**re: Grading and Site Servicing Plan Review**  
**Proposed Self Storage Development**  
**75 Michael Cowpland Drive – Ottawa, Ontario**

**file:** PG3798-MEMO.02 Revision 3

### **Site Servicing Plan Review**

Figure 1 - Proposed Thickened Edge Slab Foundation Insulation Detail

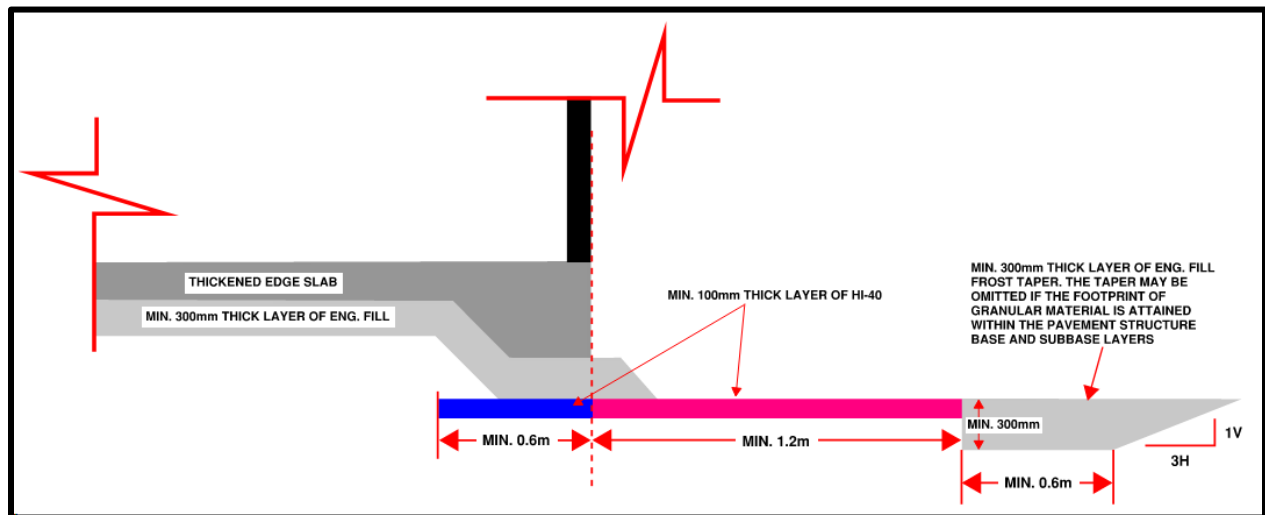
Upon discussions with the design team, the proposed thickened edge slabs are now proposed to be placed on vertical, concrete in-filled trenches where adjacent service pipes are proposed with the lateral support zone of the proposed structures. These trenches would lower the lateral support zone of the slabs below the service trenches ensuring that the proposed buildings are protected should future excavation be required for the proposed services for maintenance purposes.

Due to the anticipated depth and proximity of the proposed service pipes to the proposed thickened edge slab footprints, it is expected the lateral support zones for the proposed structures will be negatively impacted by the service installation works. Further, future maintenance that could be considered throughout the proposed service alignments would require trenches that would impact the proposed buildings lateral support zones. Based on this, it is recommended to lower the lateral support zones for thickened edge footings located adjacent to impacting service alignments. This may be accomplished by sub-excavating a near-vertical trench located directly below the overlying footing footprint and in-filled with minimum 17 MPa lean-concrete.

It is recommended the near-vertical trenches extend a minimum of 150 mm horizontally beyond the overlying footing footprint. Based on our review, the lean-concrete trench detail has been incorporated satisfactorily into the above-noted site servicing plans. The recommended perimeter thickened-edge slab foundation insulation detail is depicted below for the proposed storage structures and has been incorporated satisfactorily in the above-noted site servicing plans. The placement of the lean-concrete trench and rigid insulation should be reviewed and approved by Paterson personnel at the time of construction.

CHECKED BY:  
 T.R.B.  
 APPROVED BY:  
 T.R.B.  
 SHEET NUMBER  
**C-001**  
 ISSUE  
**3**

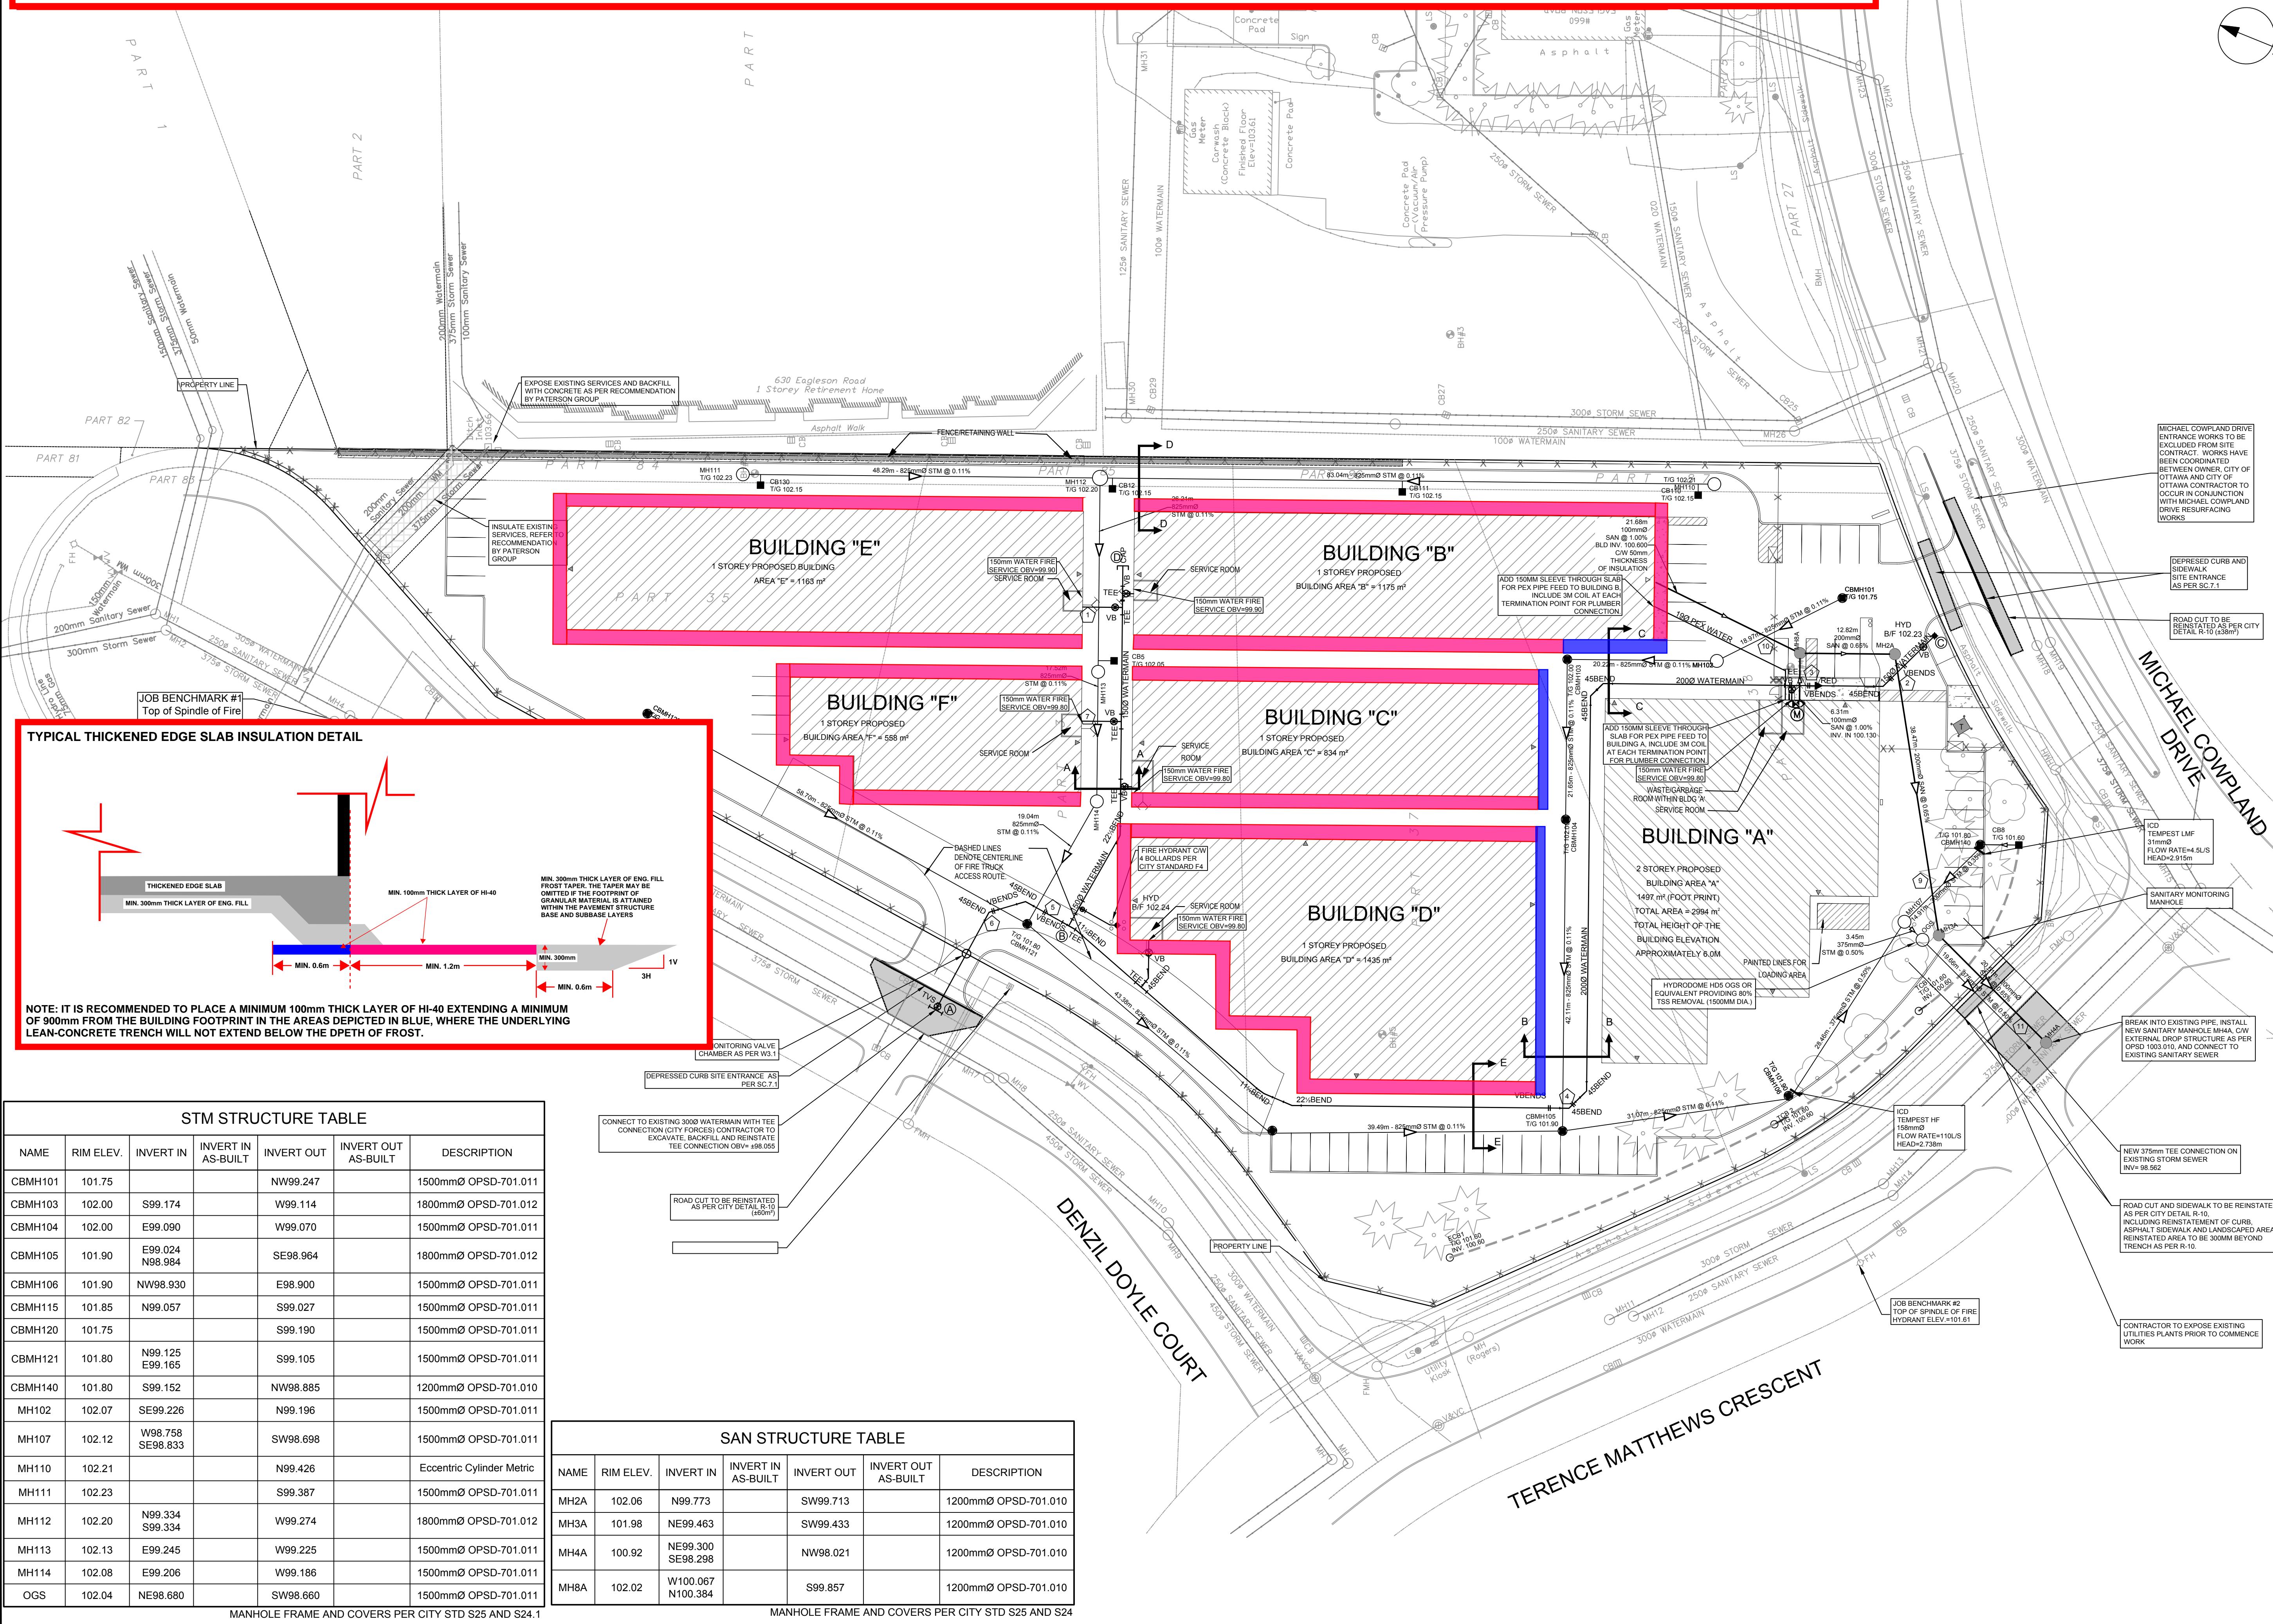
Based on our review of the above noted site service plans, the majority of the design details are considered to be acceptable from a geotechnical perspective. All proposed service pipes are sufficiently covered by adequate soil cover with no frost protection required.
